CONCEPT SITE PLAN OVERLAY - NOT FOR CONSTRUCTION - NOT A SURVEY

OPTION 1 - PLAN MIRRORED (GARAGE ON WEST, DRIVEWAY SIDE); HOUSE PARALLEL WITH SIDE LOT LINES

40'x45' main body rotated 6.3 deg clockwise from the sheet vertical (mean bearing of the side lot lines), centred between the 15' side setback lines with its rear wall on the rear setback line. Recommended orientation and side - see notes.
Base drawing: PLACES Associates, Inc. Existing Conditions Plan, Project 5827 / Plan 5827-ECP dated Sept. 11, 2026 (1"=10'). House: AFAB Enterprises 'New Single Family Residence' plan set (file "Carter", sheets 1, 3, 4, 5; 1/4"=1'-0"). Overlay prepared 22 Sept. 2026.

LOCATION: 199 CENTRAL STREET

SHEET 3 - ORIENTATION STUDY: PARALLEL WITH THE LOT vs. SQUARE TO CENTRAL STREET

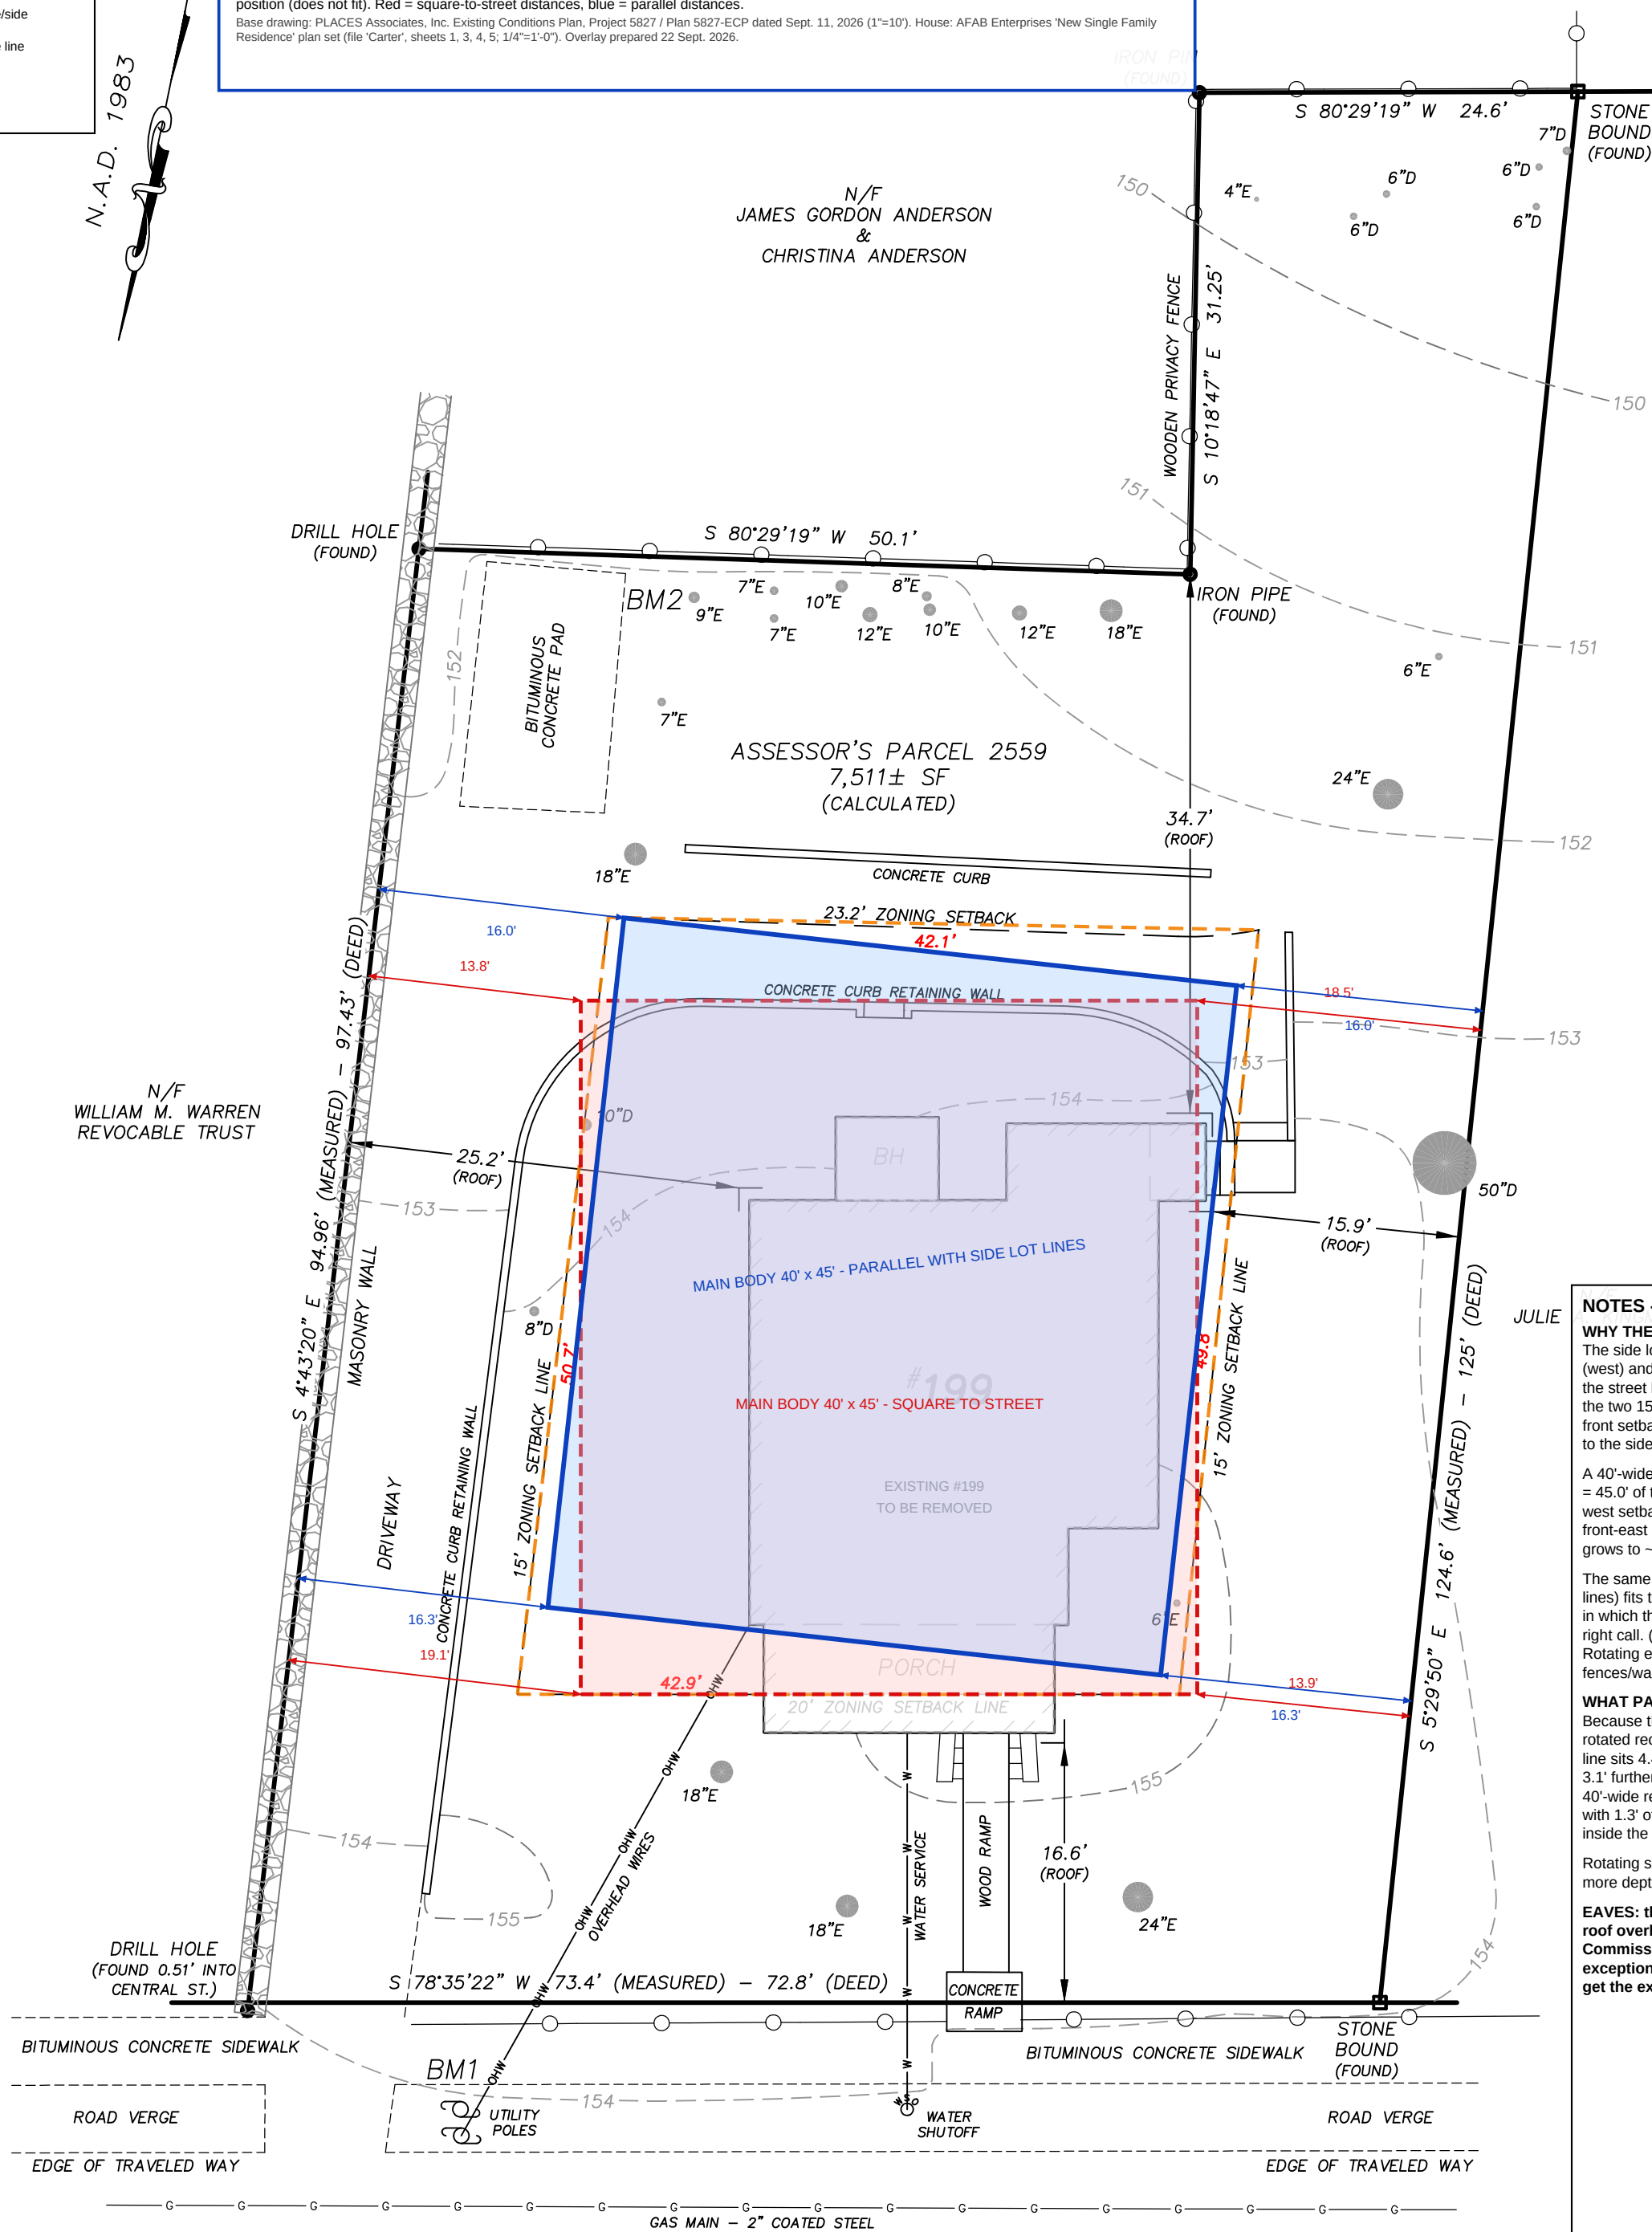
WHY THE HOUSE SHOULD BE PARALLEL WITH THE SIDE LOT LINES
The side lot lines are not square to Central Street: on the ECP they lean 6.7 deg (west) and 5.9 deg (east) toward the east as they run away from the street, while the street line runs straight across the sheet. The buildable envelope between the two 15' side setback lines is therefore a slanted strip: 42.9' wide along the front setback line and 42.1' along the rear one, i.e. about 42.4' measured square to the side lines.

A 40'-wide house set SQUARE TO THE STREET needs 40' + 45' x tan(6.3 deg) = 45.0' of that strip over its 45' depth, so it cannot fit: at best it is ~1.1' over the west setback line at its rear-west corner and ~1.1' over the east line at its front-east corner (red). Add the 7'-6" garage/porch projection and the shortfall grows to ~1.5' per side, before any eave overhang.

The same house ROTATED 6.3 deg (parallel with the mean bearing of the side lines) fits the strip with ~1.0' to spare on each side (blue). It is the only orientation in which the 40' width clears both 15' side setbacks, so 'parallel with the lot' is the right call. (The existing house is square to the street, but it is only 27.5' wide.) Rotating exactly parallel also keeps the house visually consistent with the side fences/walls; the ~6 deg skew to the street is barely perceptible from the road.

Because the front and rear setback lines are not square to the rotated house, the rotated rectangle loses depth at opposite corners: across the 40' width the front line sits 4.4' further 'back' at the east end than at the west end, and the rear line 3.1' further 'forward' at the west end than at the east. Net effect: a rotated 40'-wide rectangle can be at most ~46.3' deep on this lot. The 45' main body fits with 1.3' of side; the 7'-6" garage/porch projection (52'-6" overall) cannot be held inside the envelope in any orientation.

EAVES: the spare side clearance is only ~1.0' per side, so a typical 12"-16" roof overhang lands on or just over the 15' line. Confirm with the Building Commissioner whether eaves count (Sec. 6.2.7 also contains a 3' side-yard exception for low, <= 15'-high portions of the principal structure in Res. C - get the exact text).

Rotating slightly less than parallel (about 5.5 deg) trades side clearance for ~0.5' more depth - not enough to matter. Exactly parallel is recommended.

OPTION 3 - AS OPTION 1 BUT WITH THE FRONT PROJECTIONS CUT BACK (GARAGE 3'-0", PORCH ROOF 1'-3"): THE ENCLOSED HOUSE FITS THE SETBACK ENVELOPE

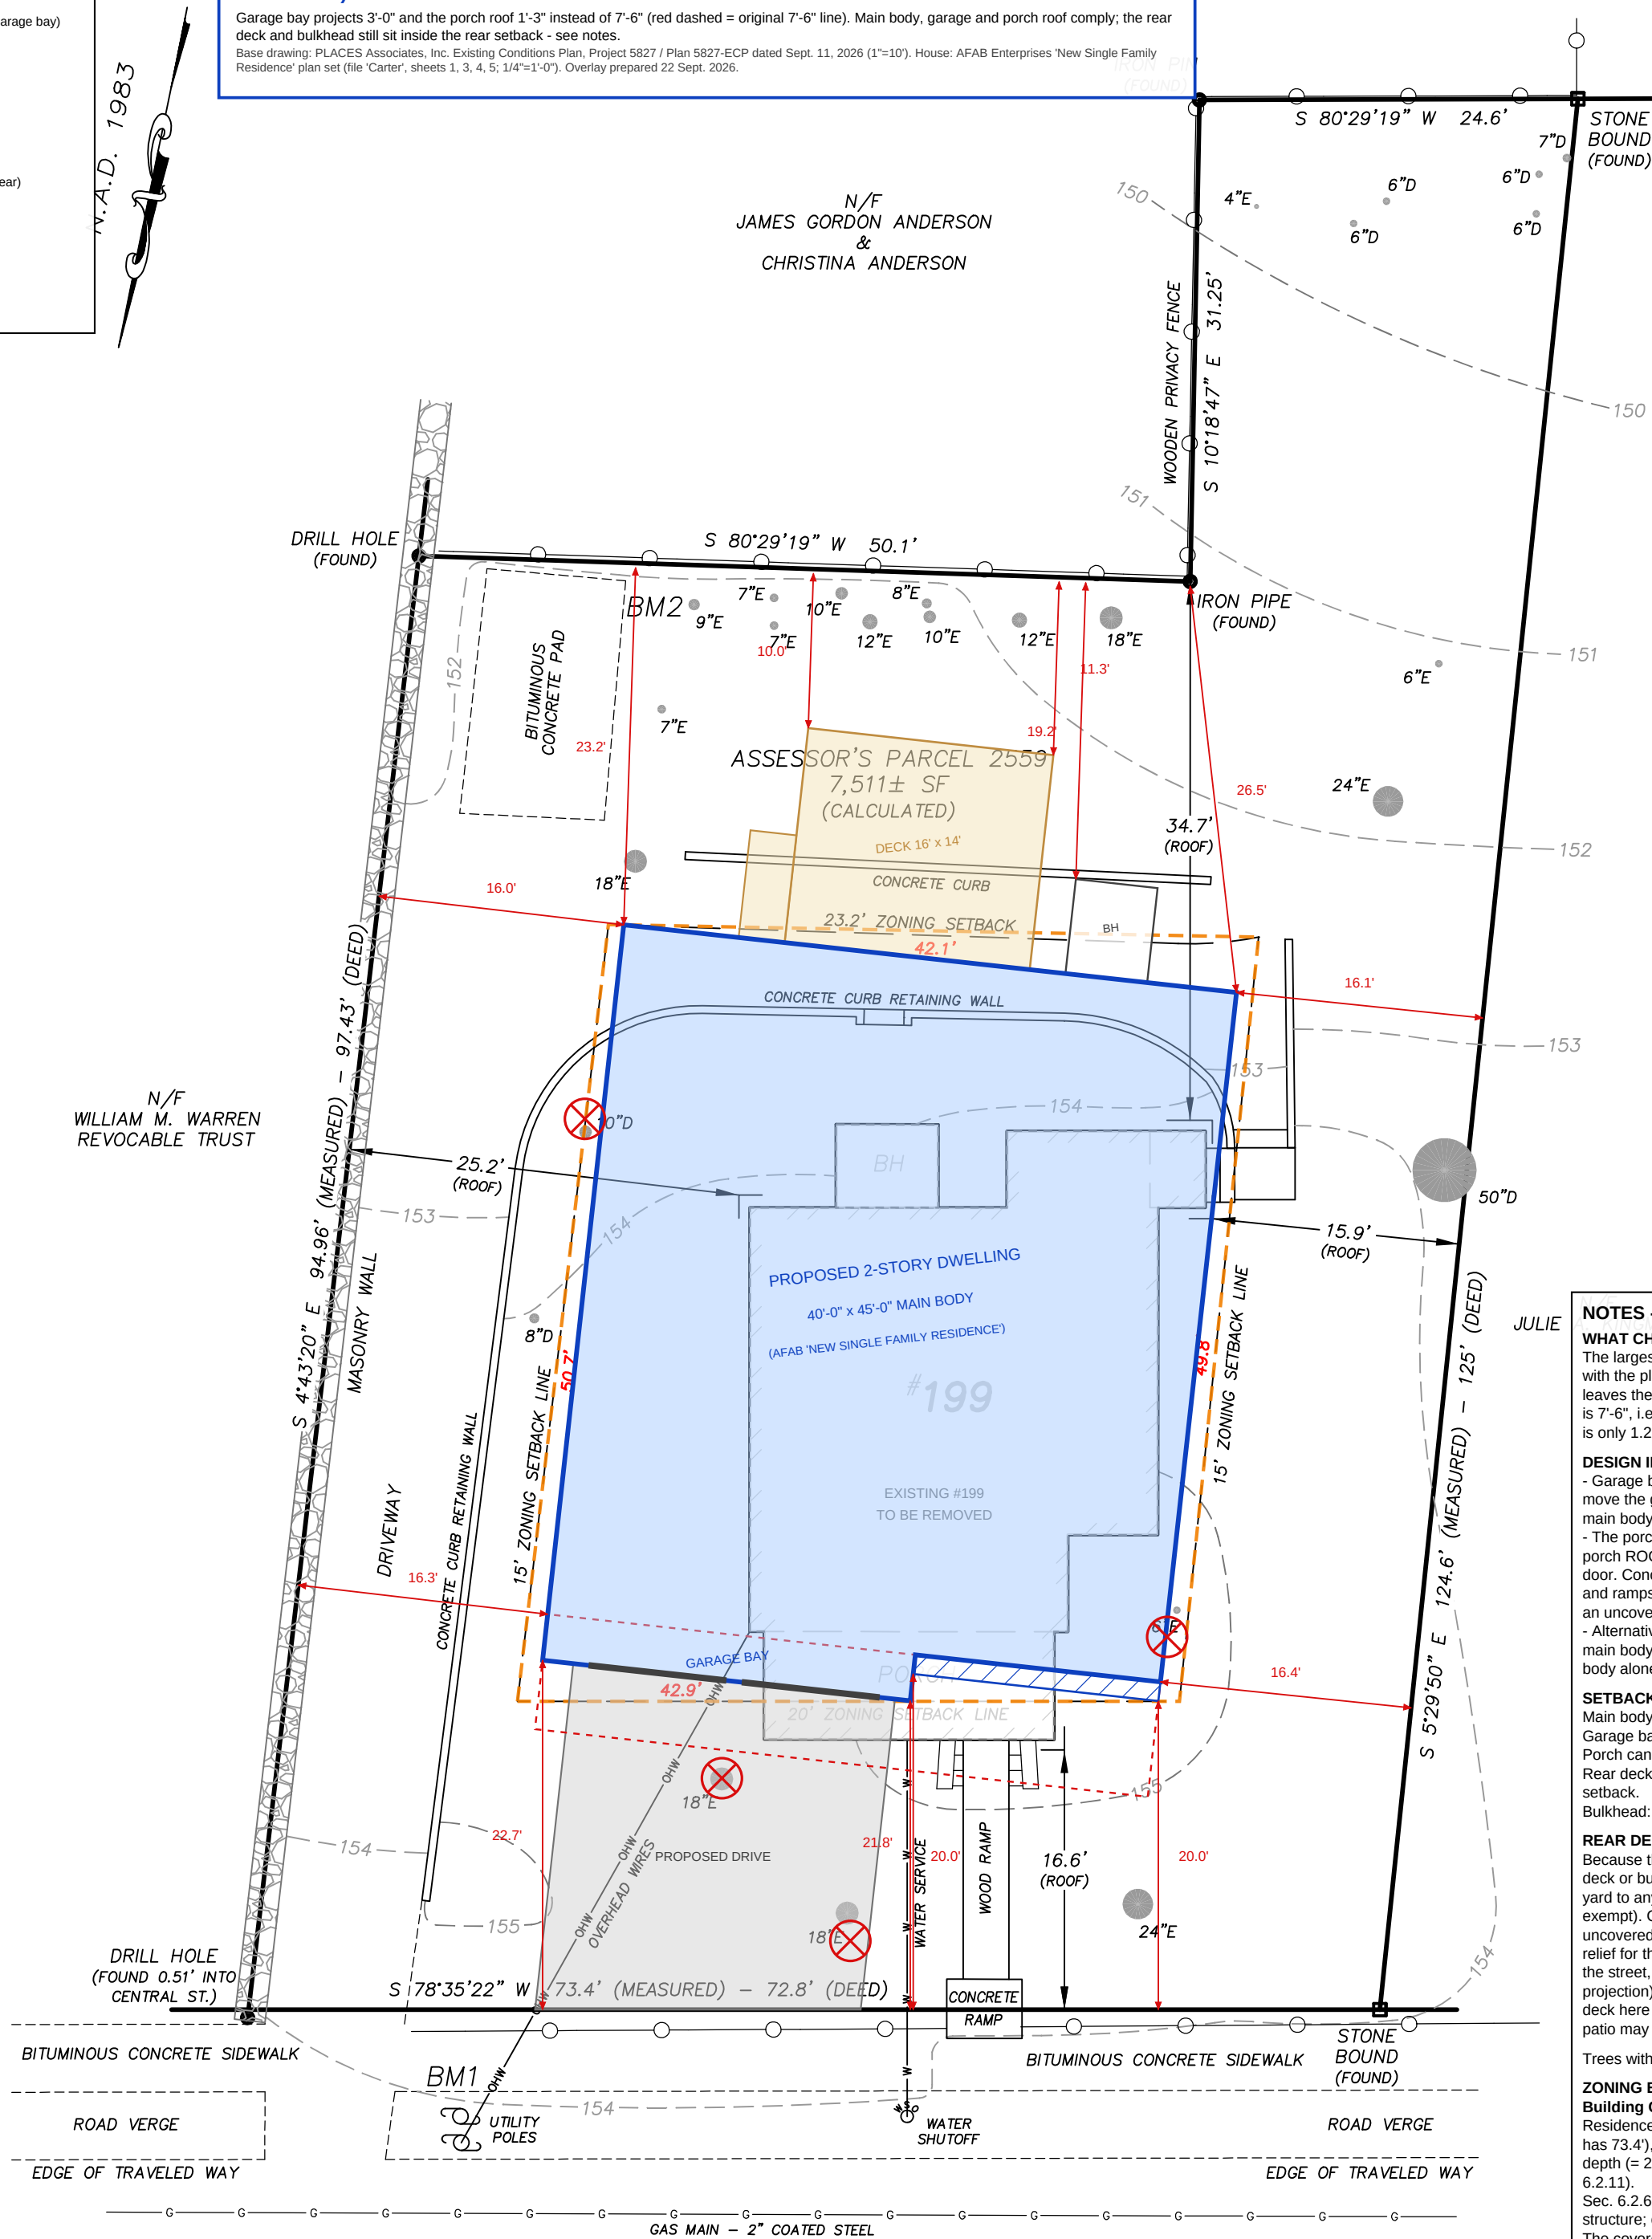
The largest front projection that keeps the enclosed house inside the envelope, with the plan mirrored (garage on the west, where the skewed front setback line leaves the most room), is 3.05'; it is drawn here as 3'-0". As drawn the projection is 7'-6", i.e. 4.5' too much. With the garage on the EAST (plan as drawn) the limit is only 1.29'.

Rear deck 16'x14': 10.0' to 11.3' from rear lot line - 13.2' INSIDE the rear setback.

Bulkhead: 19.2' from rear lot line - 4.0' INSIDE the rear setback.

Because the main body's rear wall sits ON the rear setback line, any attached deck or bulkhead is inside the rear setback, and Sec. 6.2.8 measures the rear yard to any structure attached to the dwelling (only uncovered steps/ramps are exempt). Options: (a) replace the deck with an at-grade patio/terrace reached by uncovered steps; (b) shrink the deck to a landing + steps; (c) ask the ZBA for relief for the deck only; (d) drop the bulkhead; grade at the rear is -4'-5" below the street, so a walk-out basement door in the rear foundation wall (no projection) can replace it, or use an interior basement stair. A 14'-deep first-floor deck here would stand -5'-6" above grade at its rail - a walk-out lower level with a patio may suit the site better anyway.

- Garage bay clear depth drops from 23'-4" to about 18'-10". To keep a 20'+ bay, move the garage rear wall -1'-2" into the mudroom/bench zone, or shorten the main body by the same amount.

- The porch side (east) has the least front-yard room: with the garage at 3'-0" the porch ROOF can project only 1.29' (drawn as 1'-3"), i.e. an entry canopy over the door. Concord measures the front yard to any structure except uncovered steps and ramps (Sec. 6.2.6), so the 7'-6" covered porch cannot be kept without relief; an uncovered stoop and steps may still project.

- Alternative with the same effect: keep the 7'-6" front projection and shorten the main body from 45' to -40'-6", or drop the projection and lengthen nothing (main body alone has 1.3' of slide).
